SYSTEM/MODEL: TD-H/B

MODIFICATION: Change the call-in time from DE-UR to TD-H/B phones

CHANGE THE CALL-IN TIME FROM THE DE-UR

DE-UR Schematic Diagram

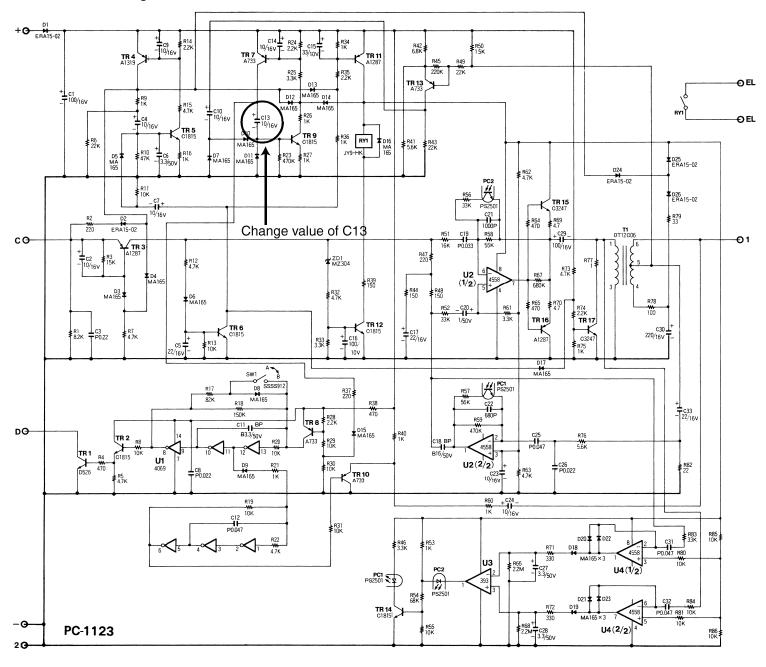
INSTR/OPERATIONS: 1. Remove and replace C13, located on PC-1123 inside the DE-UR.

2. Adjust the value of the capacitor to achieve the desired length of call-in time from the door station.

- 3. For a shorter call-in time, use a $4.7 \sim 6.8 \,\mu$ fd capacitor.
- 4. For a longer call-in time, use a 15 µfd or greater capacitor.
